PLANNING & ZONING COMMISSION SPECIAL MEETING MONDAY, NOVEMBER 9, 2020 - 12:00 PM MCALLEN DEVELOPMENT CENTER, 311 NORTH 15TH STREET EXECUTIVE CONFERENCE ROOM Web: <u>https://zoom.us/join</u> or phone: (346) 248-7799 Meeting ID: 672 423 1883

- 1) SUBDIVISIONS:
 - a) Vacate and Resubdivision of Phase One Office Park Subdivision to Avanti Legacy Valor Heights Subdivision; 220 South 1st Street -Frank A. Smith Sales, Inc. (Revised Final) (SUB2020-0074) CE

Reviewed On: 11/6/2020

SUBDIVISION NAME: AVANTI LEGACY VALOR HEIGHTS	
REQUIREMENTS	
STREETS AND RIGHT-OF-WAYS	
South 2nd Street: 40 ft. from centerline for 80 ft. of ROW Paving: 65 ft. Curb & gutter: both sides	Applied
South 1st Street: 30 ft. from centerline existing for 50 ft. of ROW Paving: 32 ft. Curb & gutter: Both sides **Monies must be escrowed if improvements are not built prior to recording.	Applied
Beaumont Avenue: 25 from centerline for 50 ft. of ROW Paving: 32 ft. Curb & gutter: Both sides **Monies must be escrowed if improvements are not built prior to final.	Applied
Paving Curb & gutter	Applied
Paving Curb & gutter	Applied

AVANTI LEGACY VALOR HEIGHTS

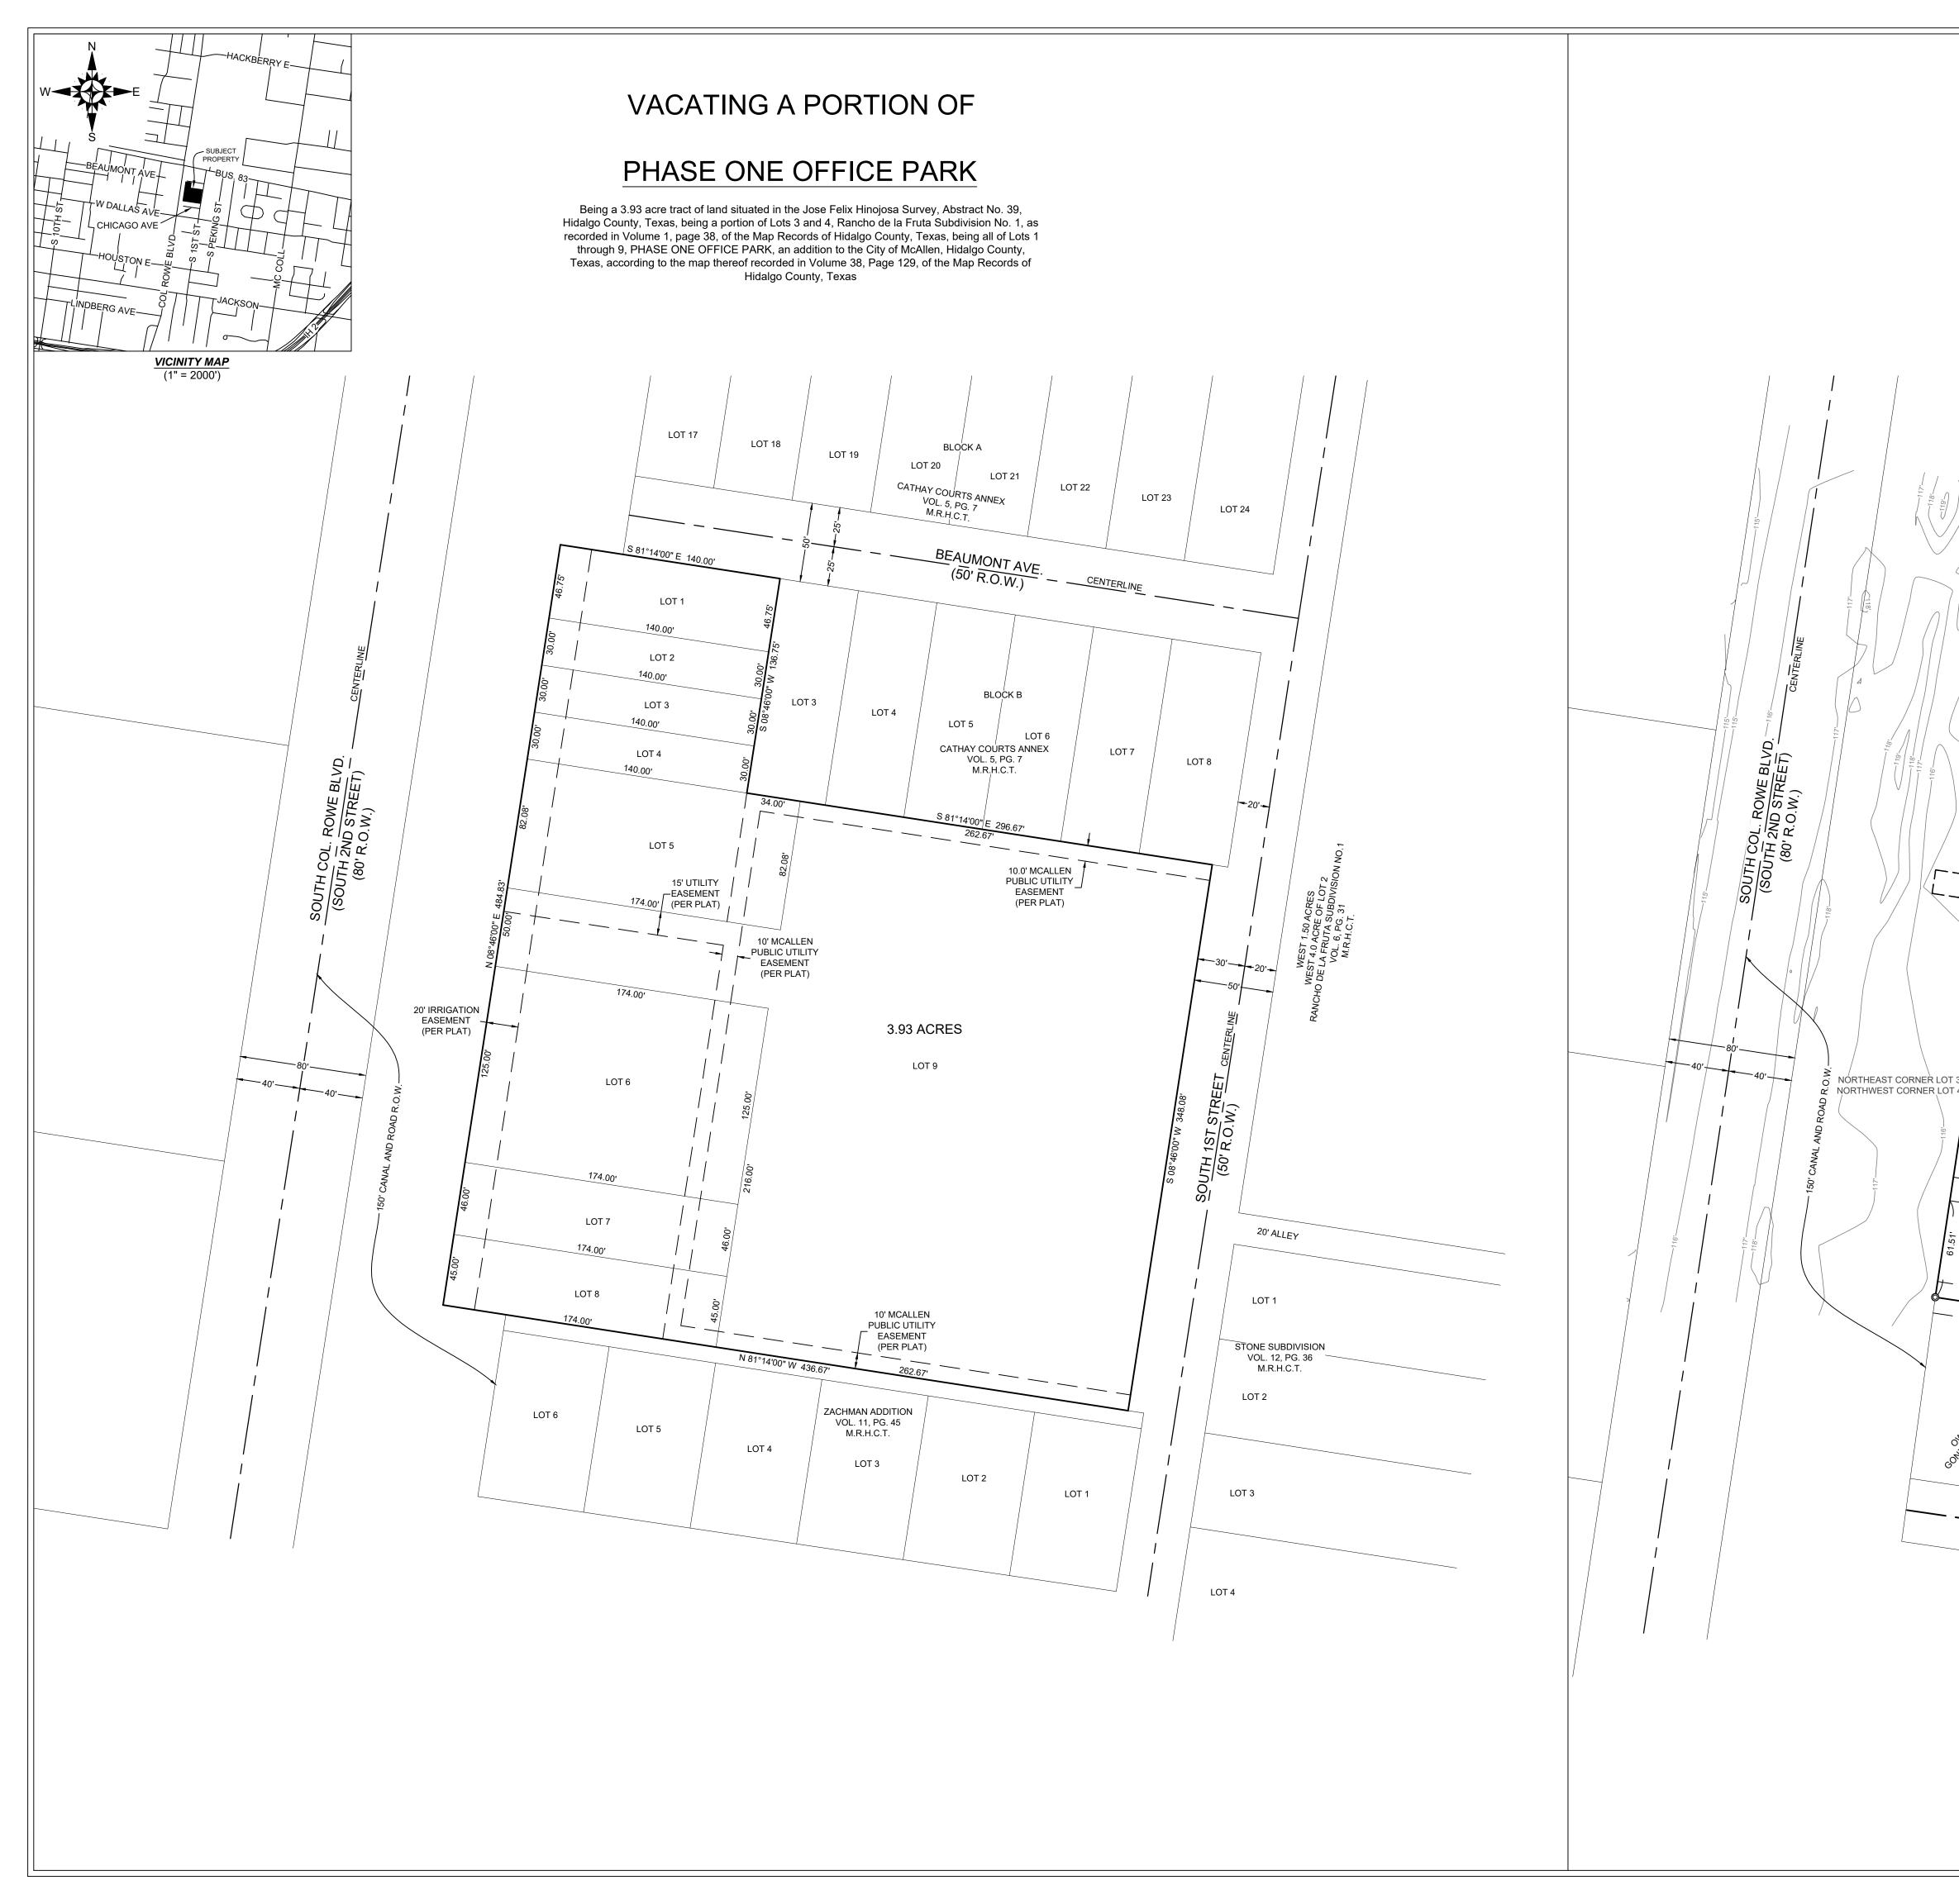
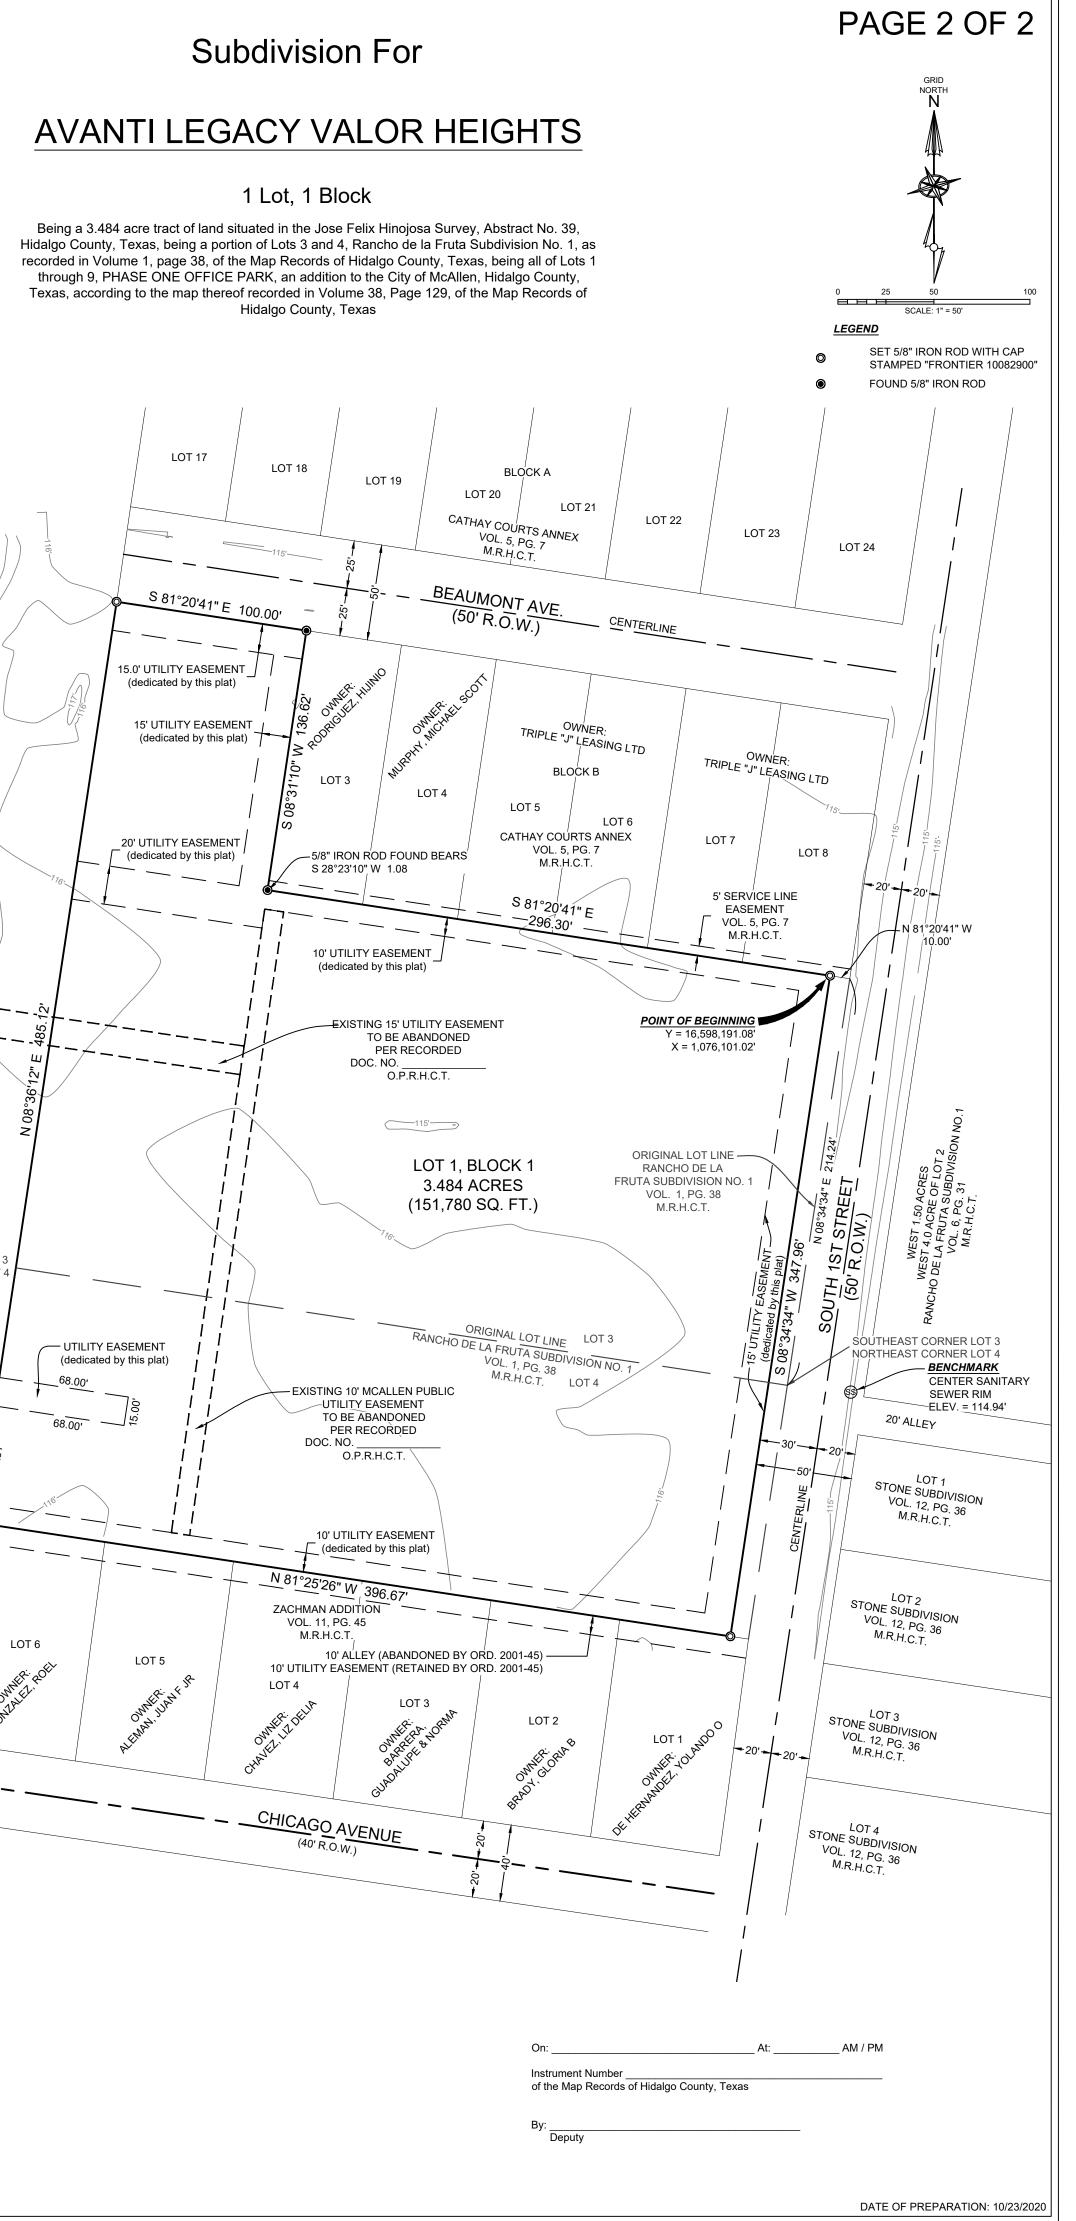
* 800 ft. Block Length.	NA
* 600 ft. Maximum Cul-de-Sac.	NA
ALLEYS	
ROW: 20 ft. Paving: 16 ft. *Alley/service drive easement required for commercial properties.	Applied
SETBACKS	
South 1st Street: 25 ft. or greater for easements or approved site plan. *Beaumont Avenue:25 ft. or line with existing structures but no less than the Ordinance requirements. ****South 2nd Street: 40 ft. or greater for easements.	Applied

* 4 ft. wide minimum sidewalk required on South 2nd Street, west side of South 1st Street and south side of Beaumont Avenue. **Revise plat note as shown above.	Applied

* 8 ft. masonry wall required between single family residential and commercial, industrial, or multi-family residential zones/uses and along the south property line. **Please revise plat note as shown above prior to final. ***Engineer has requested a variance to provide a 8 ft. wooden fence instead of the required 8 ft. masonry wall along the south property line. The variance will be presented before the Zoning Board of Adjustments and Appeals on their October 21, 2020 meeting. If variance is approved, plat note will have to be revised accordingly prior to recording. 	Required
*Perimeter buffers must be built at time of Subdivision Improvements.	Applied
NOTES

COMMENTS	
Comments: *Must comply with City's Access Management Policy ***Abandonment for existing utility easements by separate instrument/document will need to be finalized prior to recording.	Applied
RECOMMENDATION	
Recommendation: STAFF RECOMMENDS APPROVAL OF THE SUBDIVISION ON REVISED FINAL FORM SUBJECT TO CONDITIONS NOTED, AND ABANDONMENT BEING RECORDED.	Applied
